Staff Report: CASE # 8-23-O

The Applicant is requesting Overlay District Plan Approval from the Union Township Board of Trustees for Parcel #s 413213A190, 413213A206, 413213A319, 413213A020, 413213A292, 413213A324, 413213A327, 413213A325. Specifically, the Applicant is seeking to develop a 13,500 sq. ft. multi-tenant retail building—on approximately 1.65-acres that are located within the Mt. Carmel Business District Focus Area Overlay – Commercial Corridor (FA-CC).

4543 YATES LANE
ZONING SUBMITTAL
UNION TOWNSHIP, CLERMONT COUNTY, OHIO

LANDSCAPE PLAN

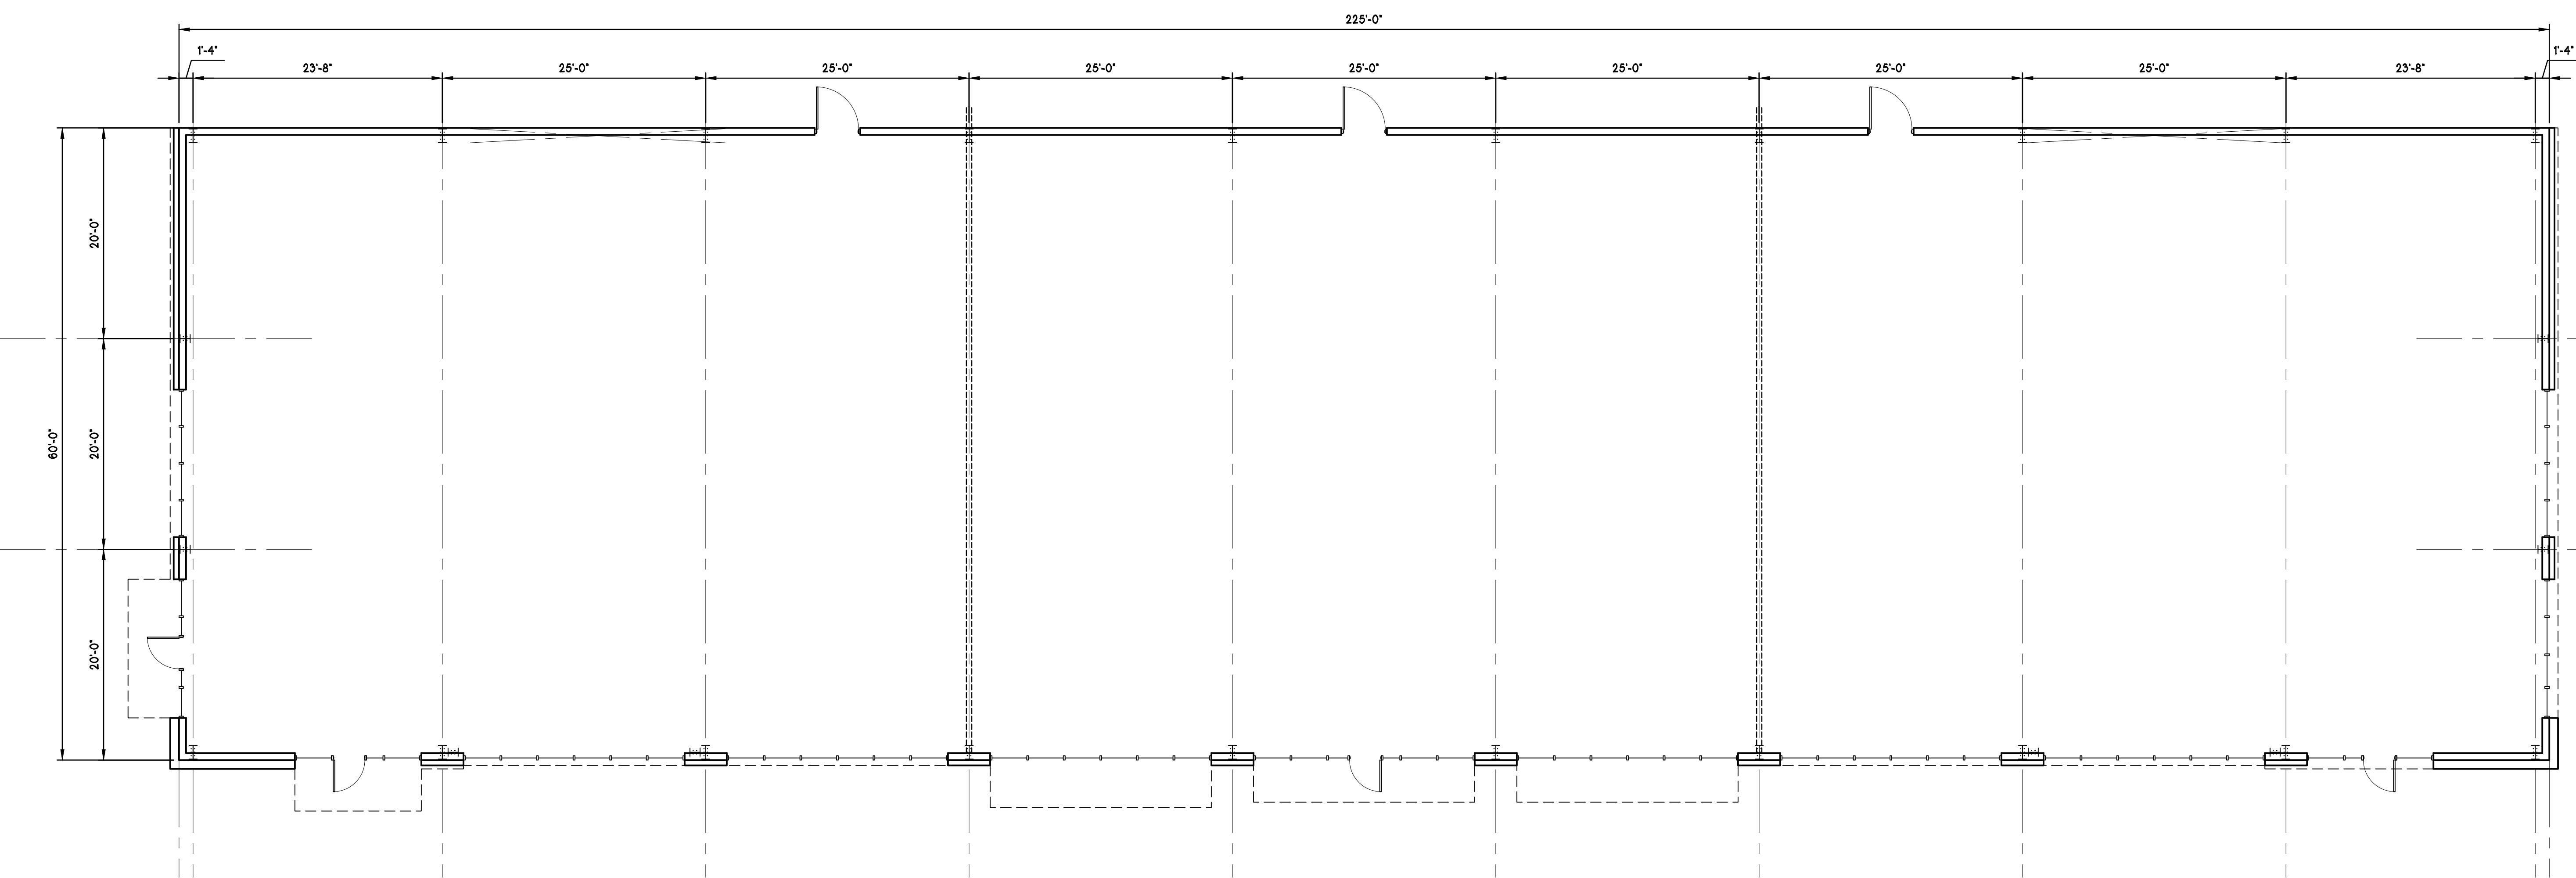
- 3) The Applicant would need to provide an enhanced landscaping plan (acknowledging the types of plantings along with the heights / sizes recommended), particularly along the southwestern side and rear areas of the site. Additionally, any *existing* landscaping to remain and proposed landscaping should be marked as preservation area(s), and any vegetation disturbed should be repaired, supplemented, or replaced. *This is an item that can be addressed administratively by staff.*
